DOCKETED	
Docket Number:	26-OPT-01
Project Title:	Vaca Dixon Power Center Project
TN #:	273293
Document Title:	Data Request #2 Responses (Response Set #3)
Description:	The Applicant's responses to the Data Request received from the CEC on October 12, 2026.
Filer:	Adam Morrison
Organization:	Rincon Consultants, Inc.
Submitter Role:	Applicant Consultant
Submission Date:	10/30/2026 9:12:51 AM
Docketed Date:	10/30/2026

Vaca Dixon Power Center Project (26-OPT-01)

CEC Data Request Response Set #3

Figure 1 - Revised Figure 5.5-1 Scenic Highways and Resources within 5 Miles

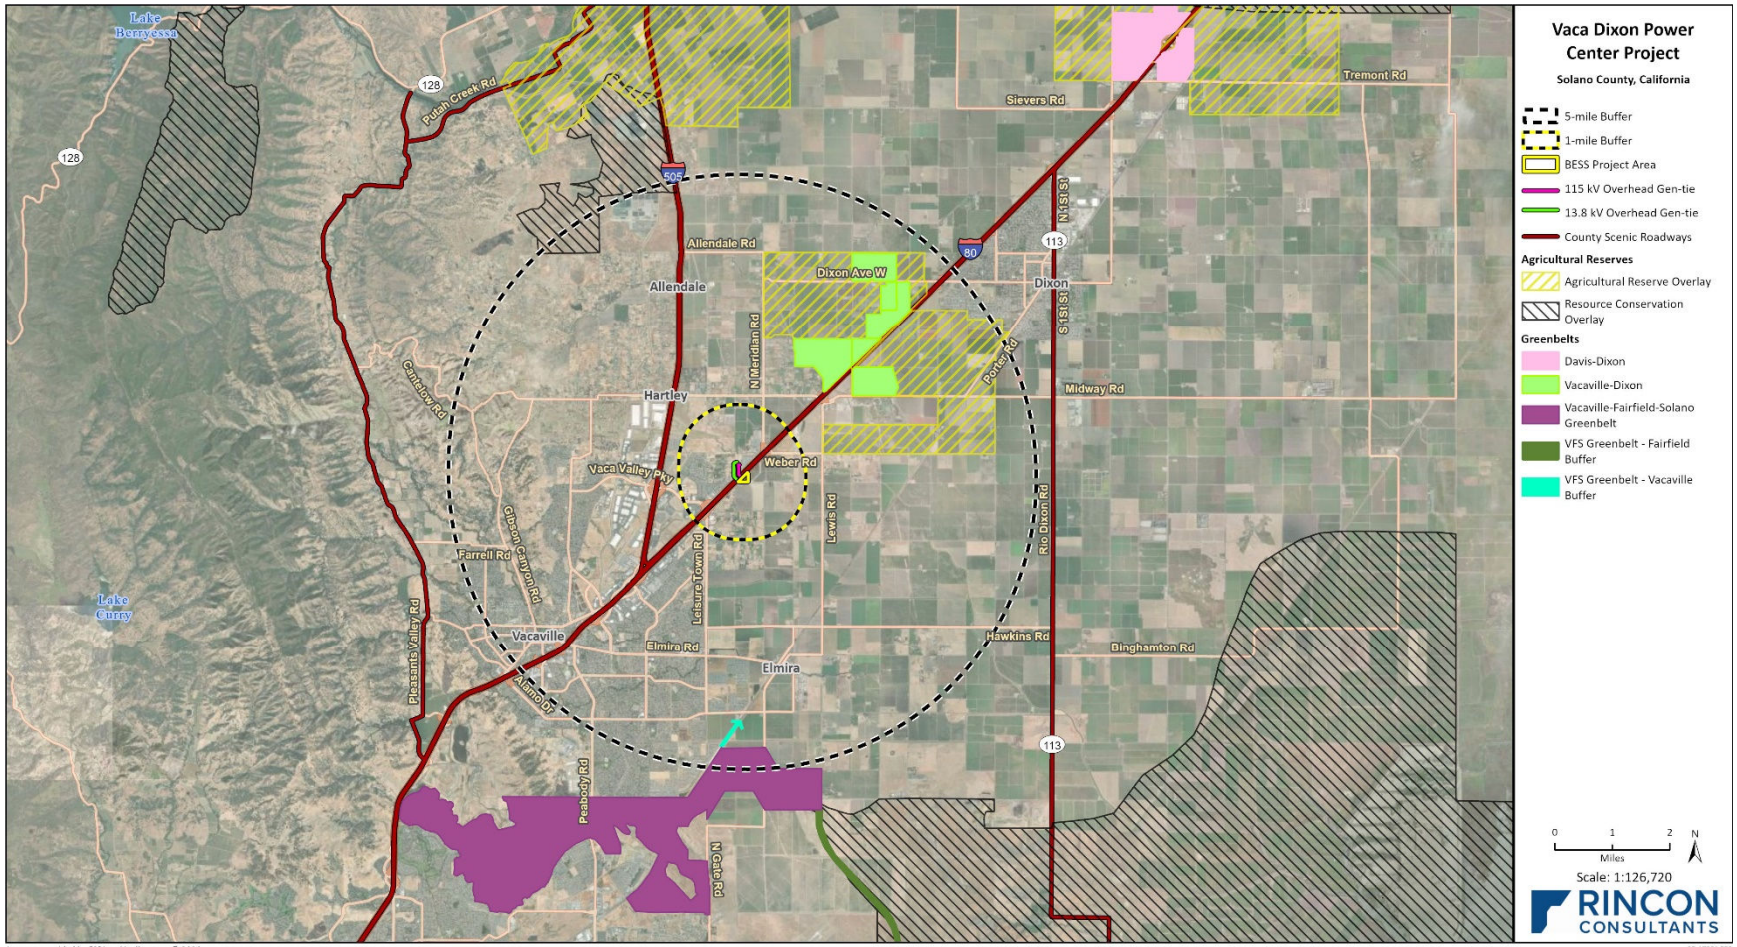
As required by CEC Regulations, a map of scenic resources within 5 miles of the project site must be submitted. Although Figure 5.5-1 (TN 270297) depicting scenic resources within 5 miles of the project was provided (TN 270286) in response to Data Request DR VIS-4, and included some Greenbelt areas, the closest greenbelt (Vacaville-Dixon Greenbelt – approximately 2.27 miles to the northeast of the project) was not mapped. Therefore, please add the Vacaville-Dixon Greenbelt to Figure 5.5-1. Please note, the Vacaville-Dixon Greenbelt overlaps with a portion of the Agricultural Reserve Overlay.

A revised figure, showing the Vacaville-Dixon Greenbelt is included as Figure 1 - Revised Figure 5.5-1 Scenic Highways and Resources within 5 Miles below.

MIDDLE RIVER POWER
VACA DIXON POWER CENTER
QUINN ROAD ALTERNATE SITE
SITE LAYOUT PLAN

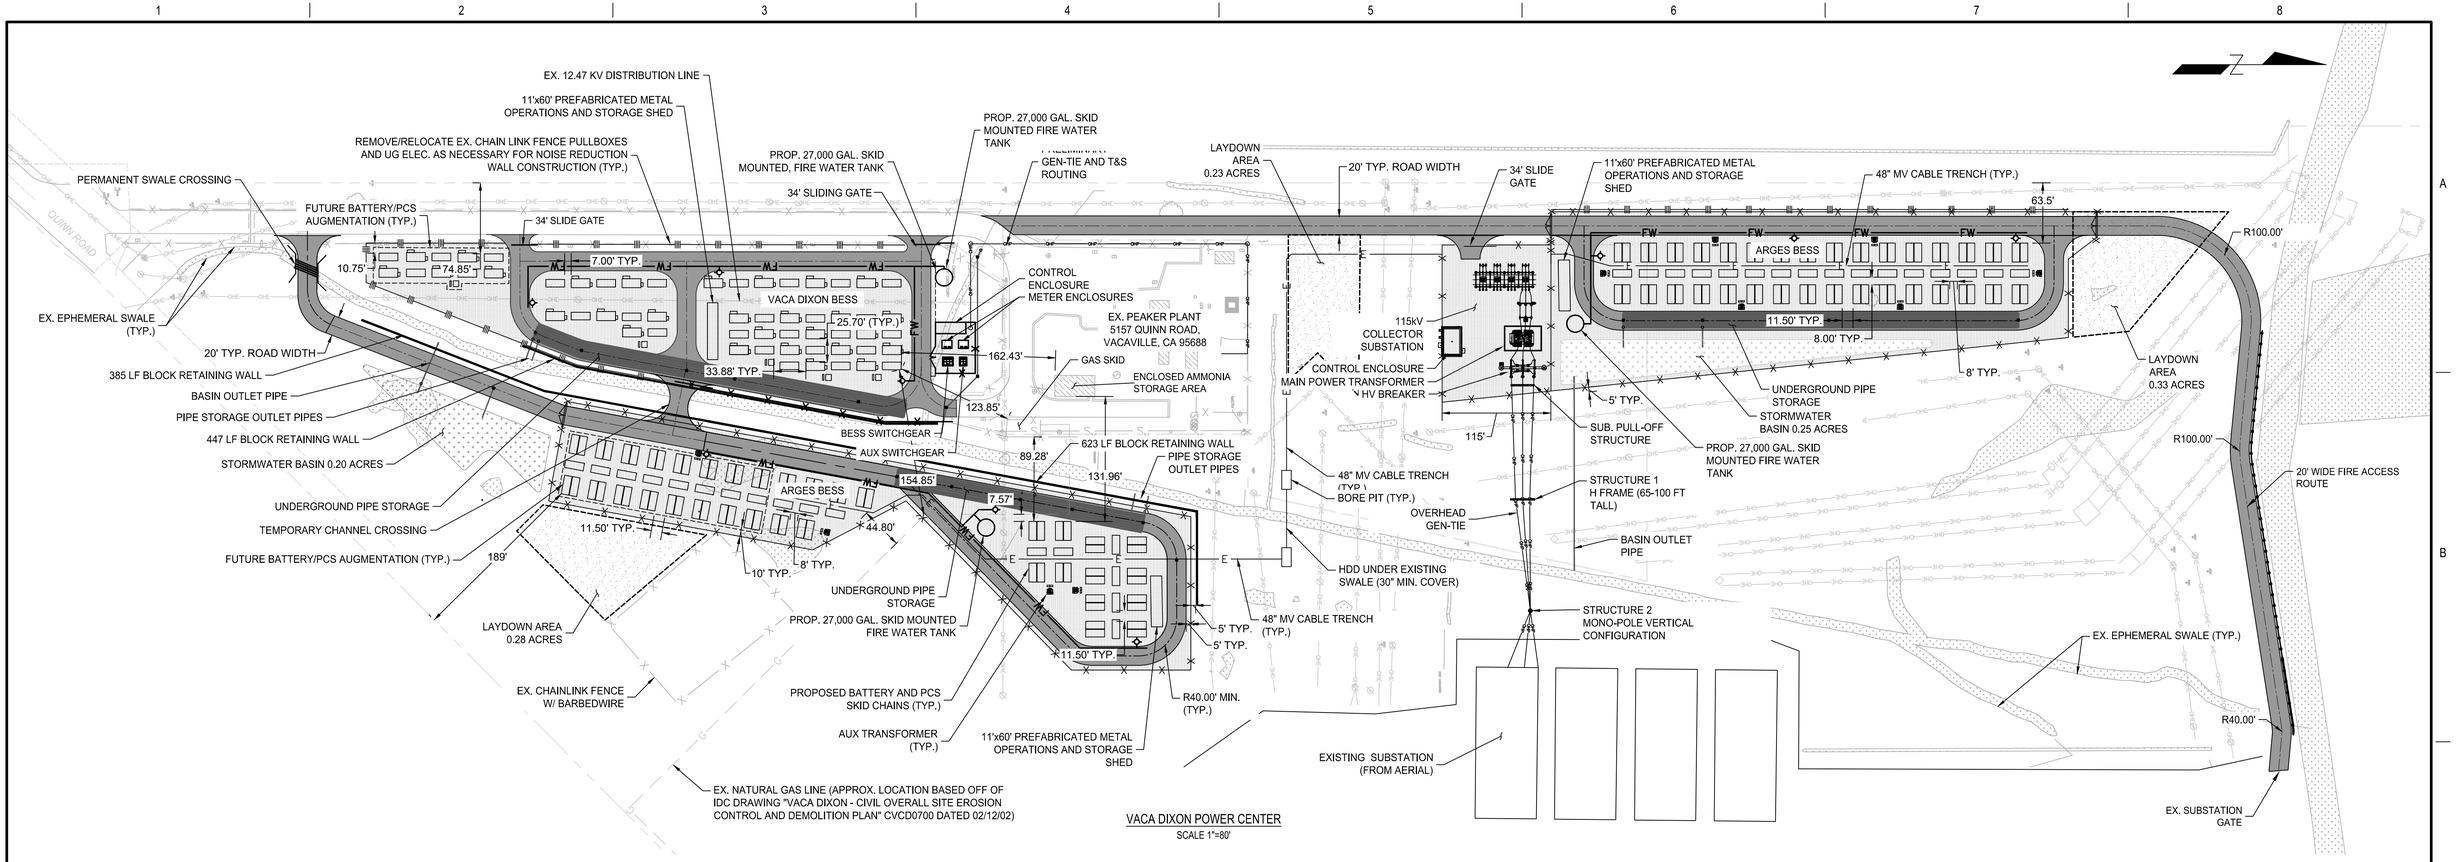
Provide an updated site component map for the Quinn Road Site Alternative that identifies the following information:

a. Locations of the BESS enclosures;
b. Separation distances between the BESS enclosures;
c. Setback distance of the BESS enclosures from the Vaca Dixon Peaker Plant site;
d. Setback distance of the BESS enclosures from the nearest sensitive receptor property line; and
e. Location of emergency (e.g., fire department) access points.

Updated layout drawings showing the requested information is included as Appendix DR 3-1 Quinn Road Site Updated Layout. Setback distances are identified in the figures included in the Appendix.
